REQUEST FOR INFORMATION

Project Name: KINDRED RESORT

Hardscapes Snowmelt Insulation

Kindred Resort @ Keystone
RFI-01245 Revision 0
response issued_04/26/2024

SHEET TITLE:
Landscape Planting
Plan: Plaza Level West

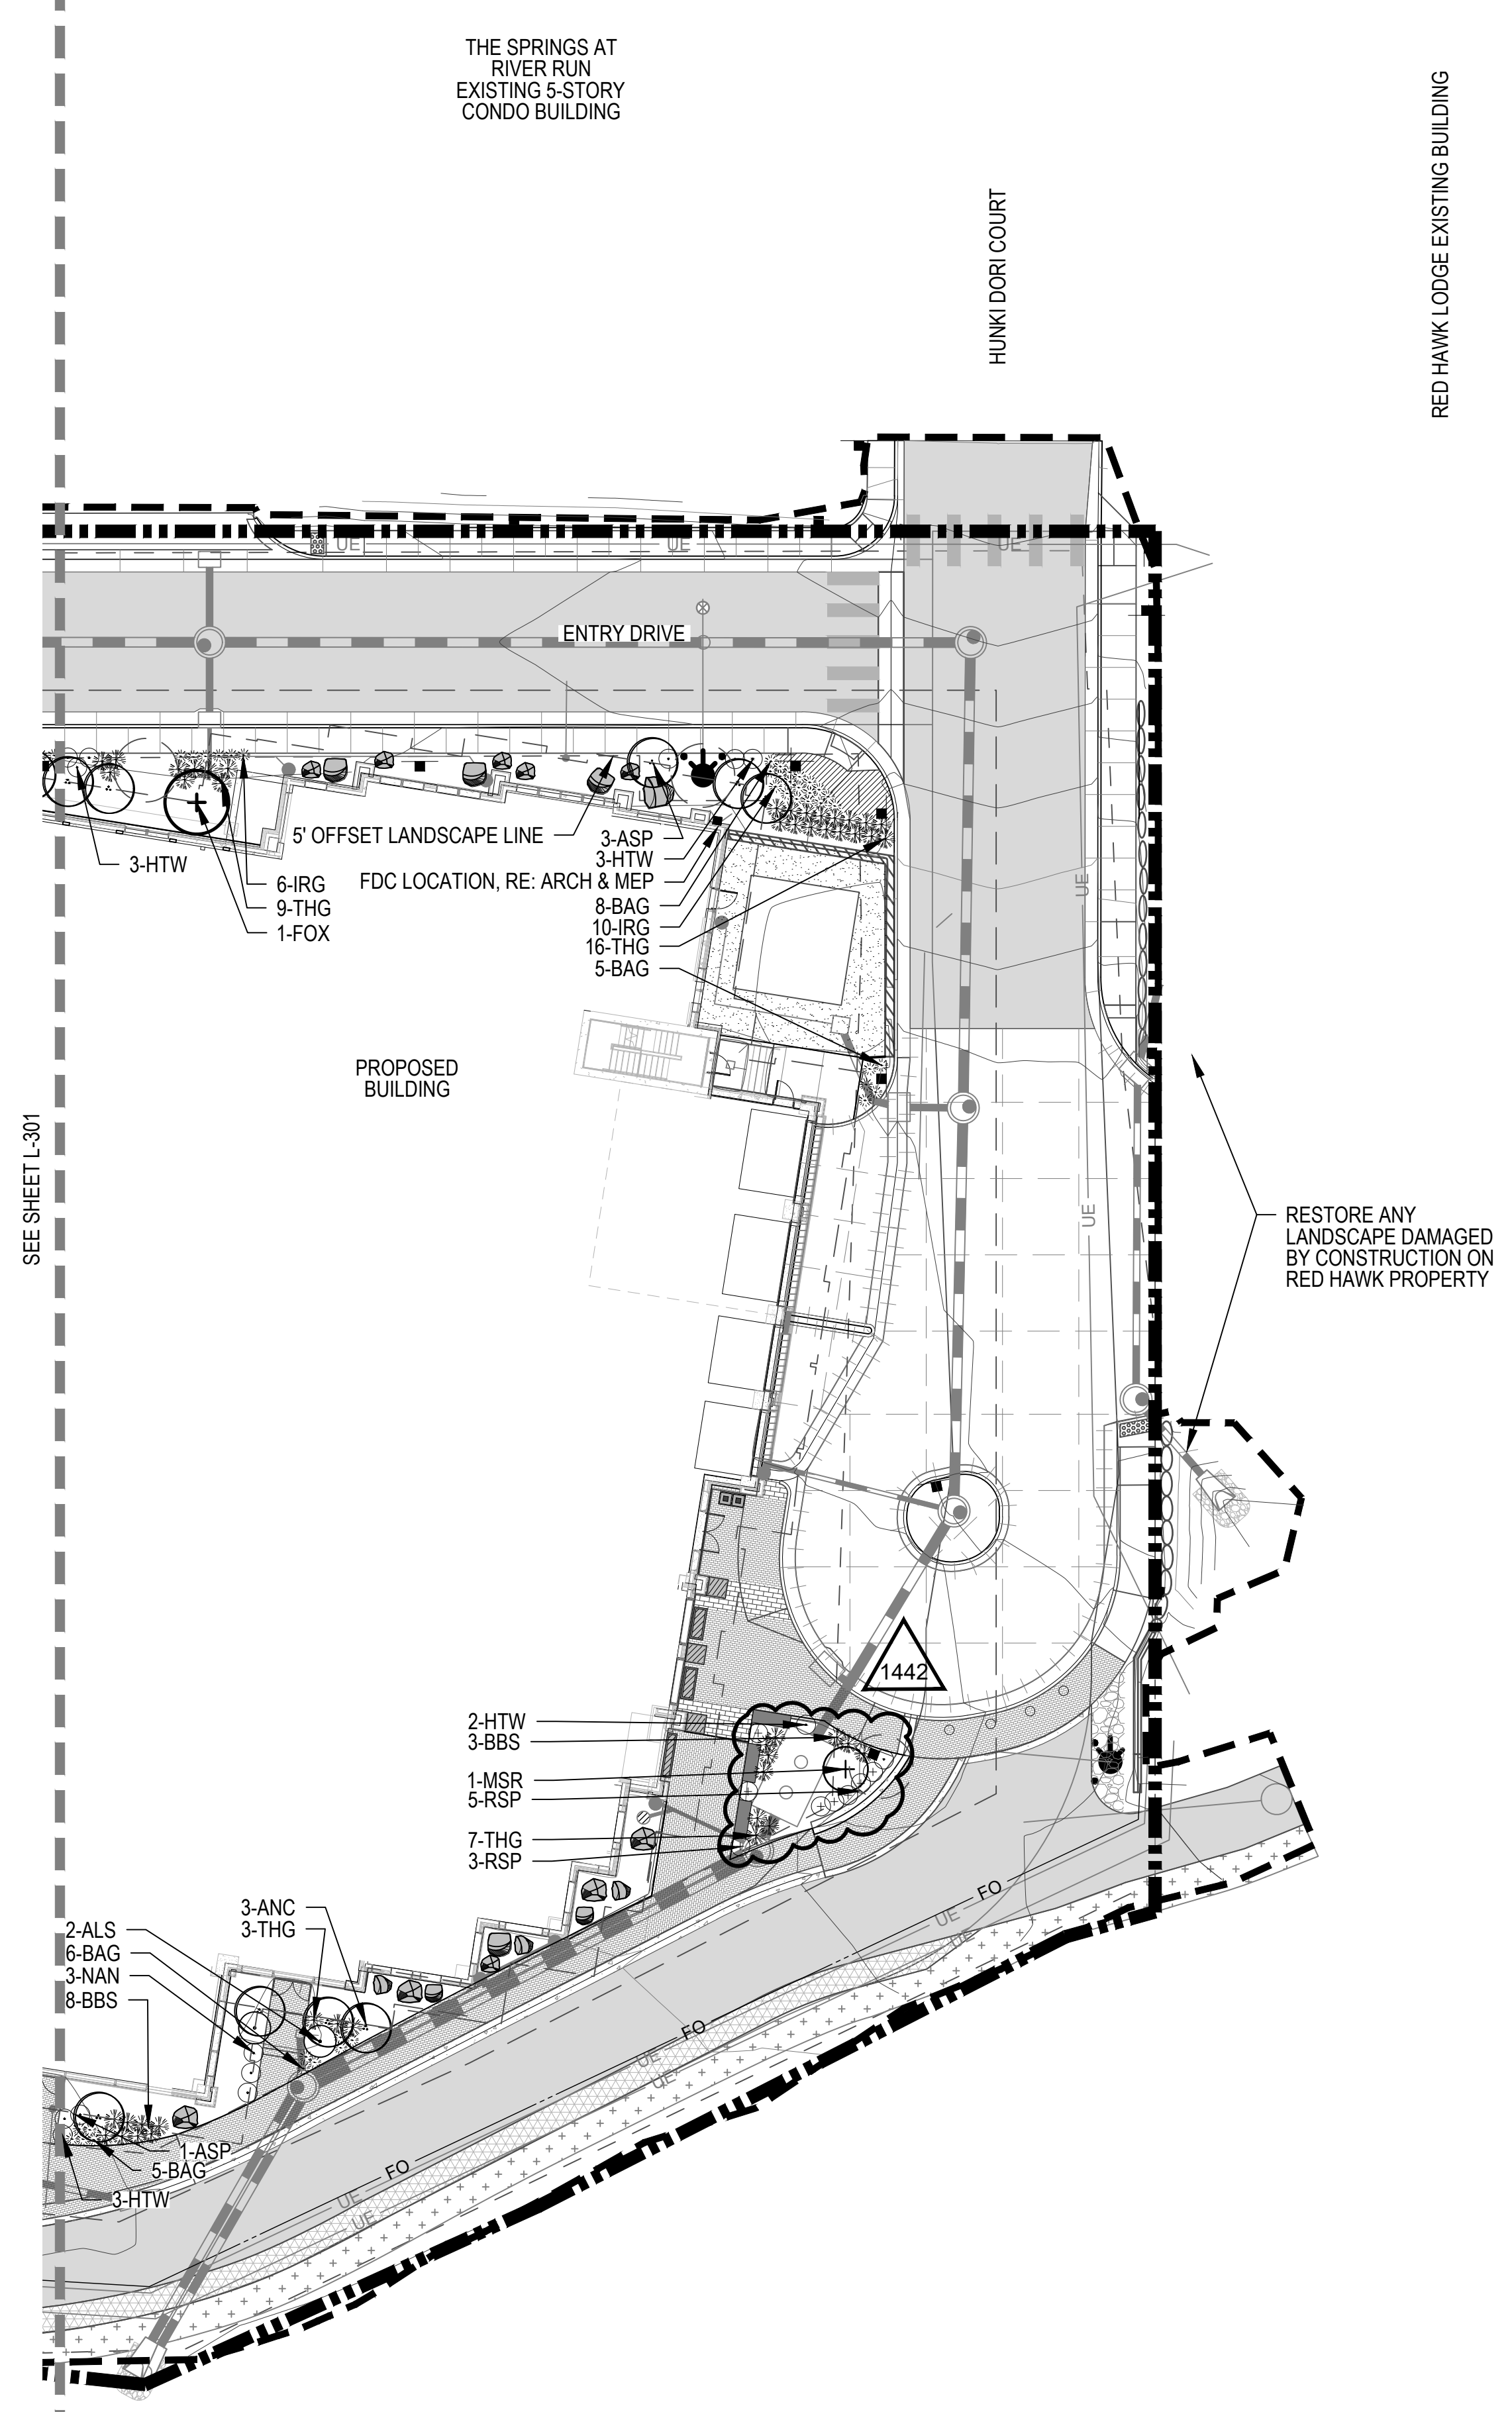
2. RFI 00059.2 provided the water quality vault location and elevation near the southeast corner of the site. Within the response it is noted that the site plan submittal will need to be updated showing revised planting locations since the quantity of planting may not be reduced. No other landscaping information was provided. The Landscape Plan L-302 shows shrubs, grasses and trees being planted in this location. Please confirm if the planting materials in this location are to be removed. If so, please provide an updated landscaping plan.

2. Please see revised sheets L-102, L-301, and L-302 for relocation of landscape materials to accommodate the vault.

ONE RIVER RUN
 ISSUED FOR:
 GMP/BUILDING PERMIT
 RESUBMITTAL
 SHEET TITLE:
 COMPOSITE UTILITY PLAN

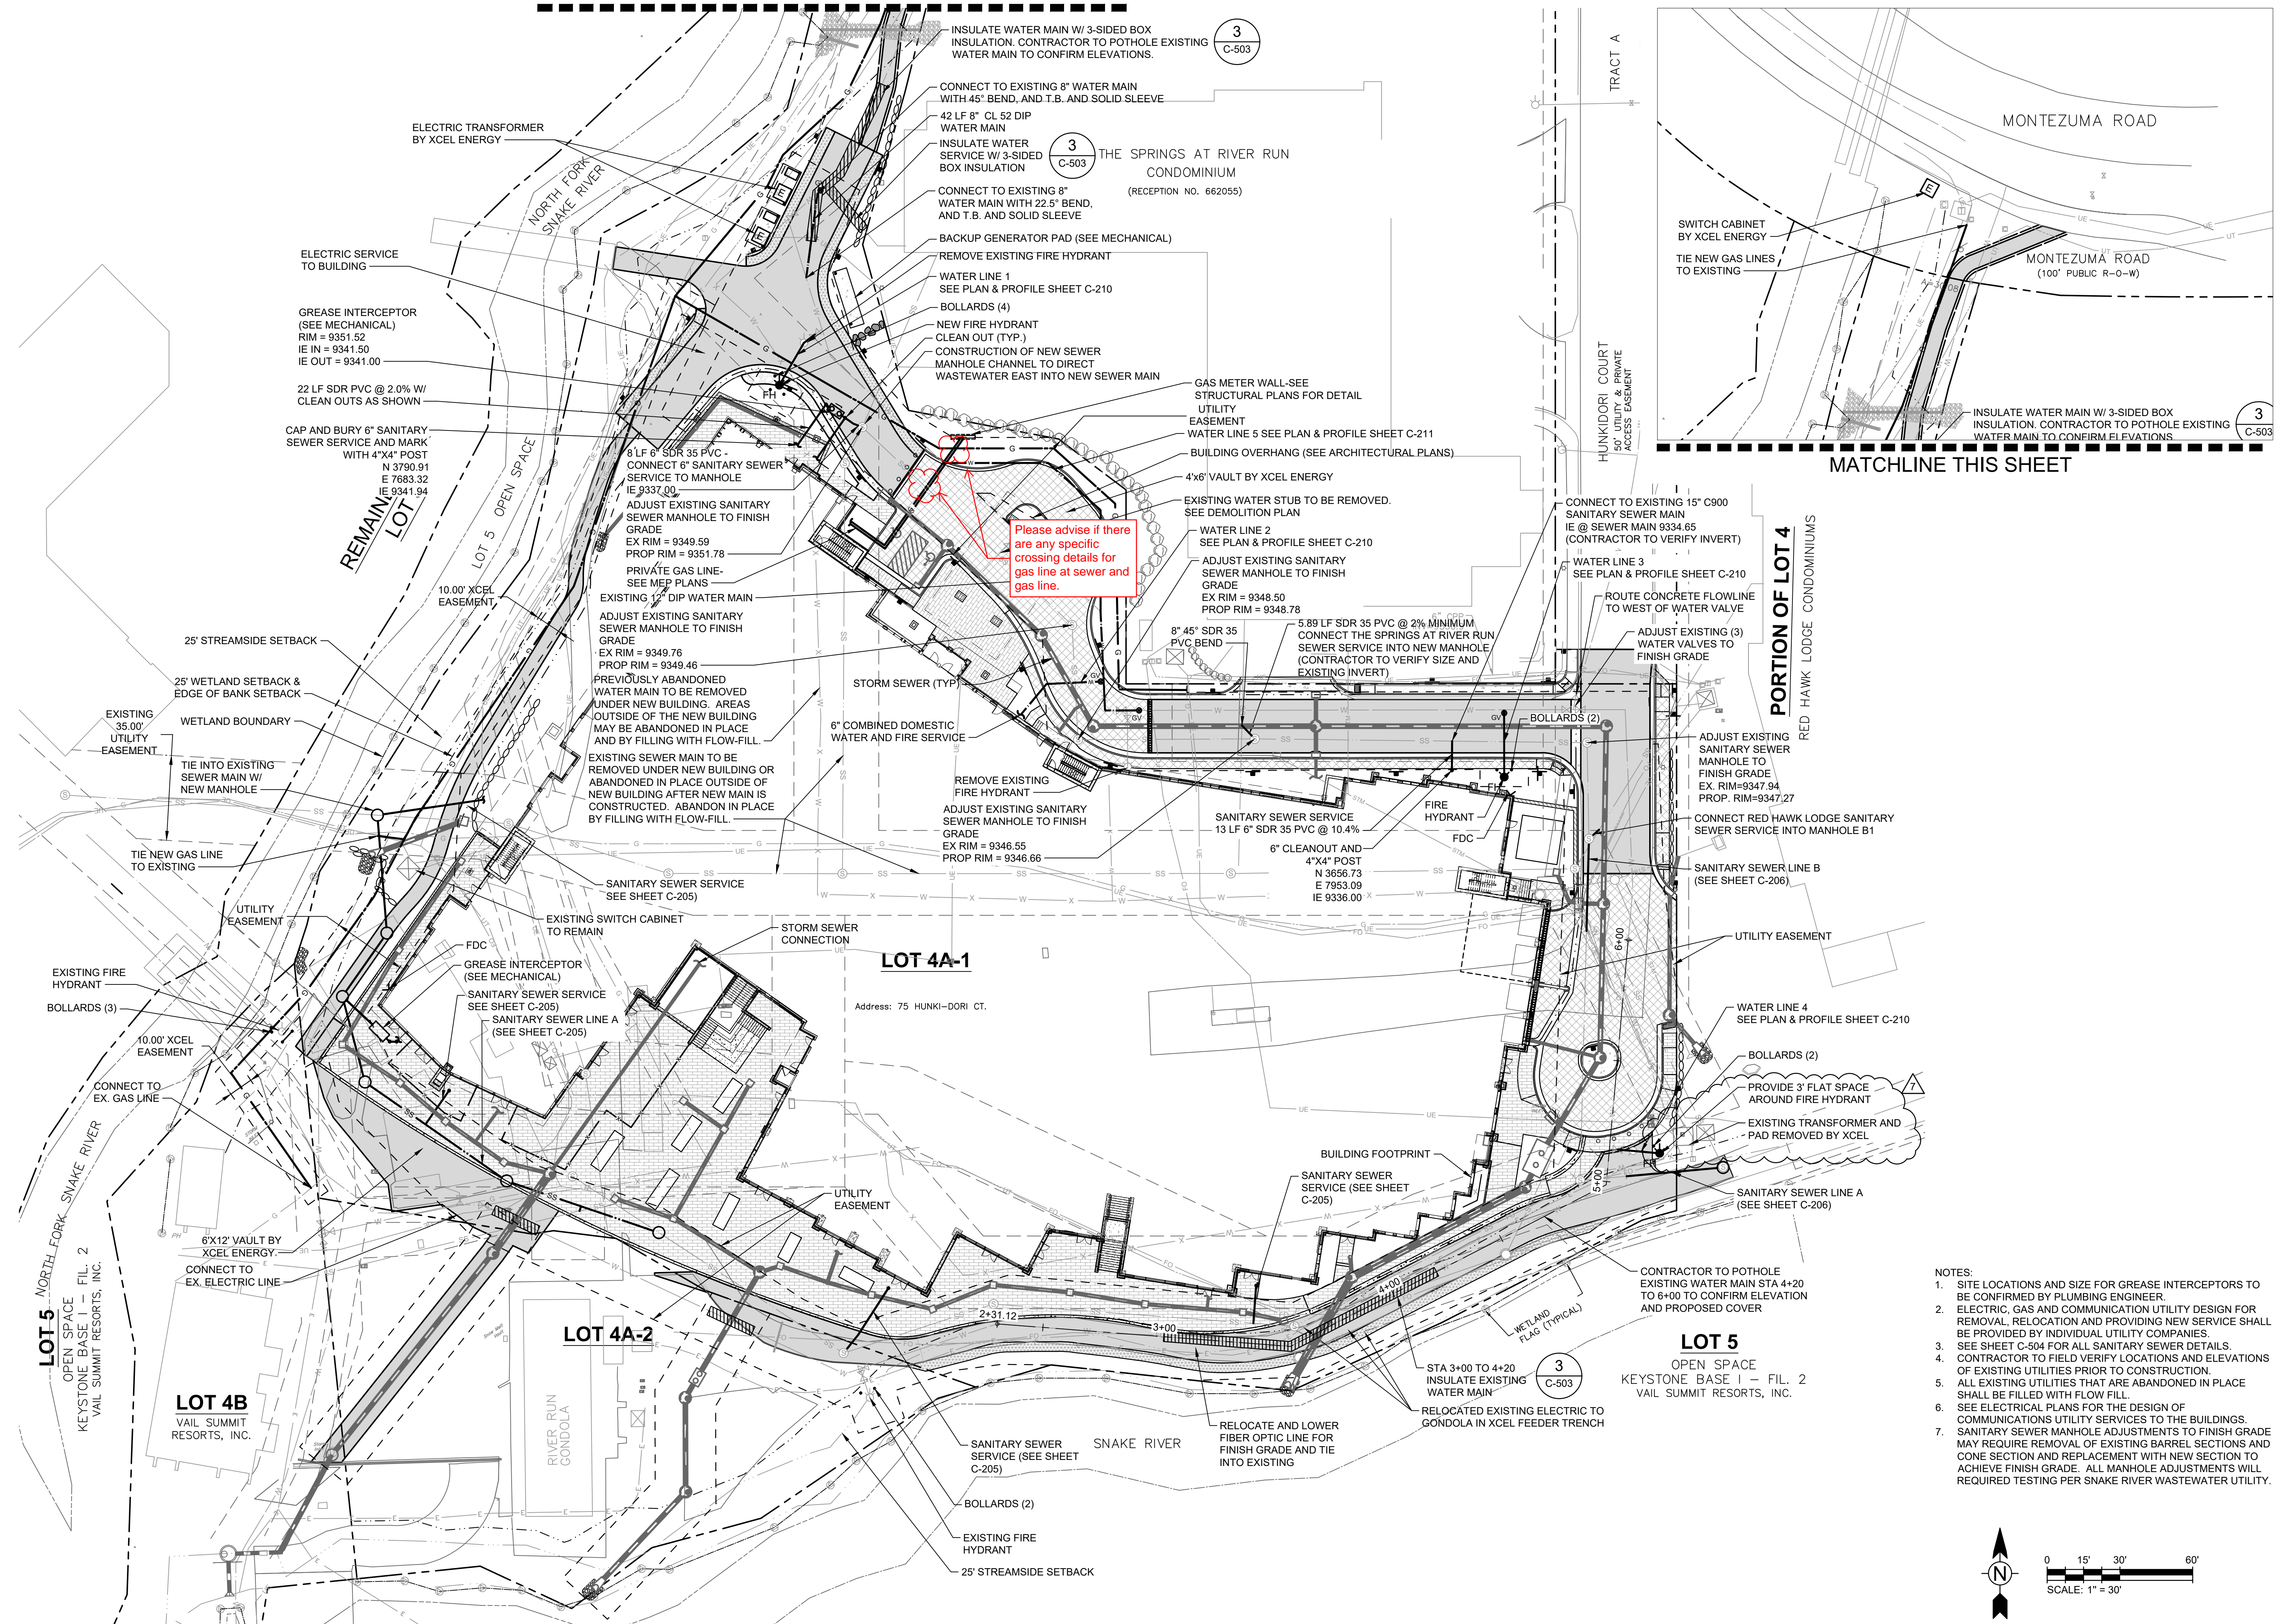
Per the civil and mechanical detail sheets there are no specific details outlining the bedding requirements for natural gas piping. Per ASI-13, gas piping is to be installed underground to the relocated gas meter. As a result of this relocation, the gas piping will be installed roughly 5.5'-6' below finish grade and will require bedding and backfill in the trench. In addition to the above, the gas lines will also be crossing under other utilities such as the storm sewer and gas line. Please advise as follows...

- 1) Please provide a backfill and bedding detail as it relates to the gas lines now being installed underground to the gas meter.
- 2) Please advise if there are any specific measures that need to be put in place at these crossing locations.

1. Mechanical is designing the gas piping and therefore should provide the bedding requirement.

2. Flowfill encase gas line at water, sewer, and storm sewer crossing if separation in less than 1'. See detail.

Per email from Ryan Selchert received 8/20/24, Xcel recommends ¾" class 6 aggregate to fill the trench (24" Min. Depth) and at least 6" below the bottom of the pipe. See civil response in red for additional clarifications.
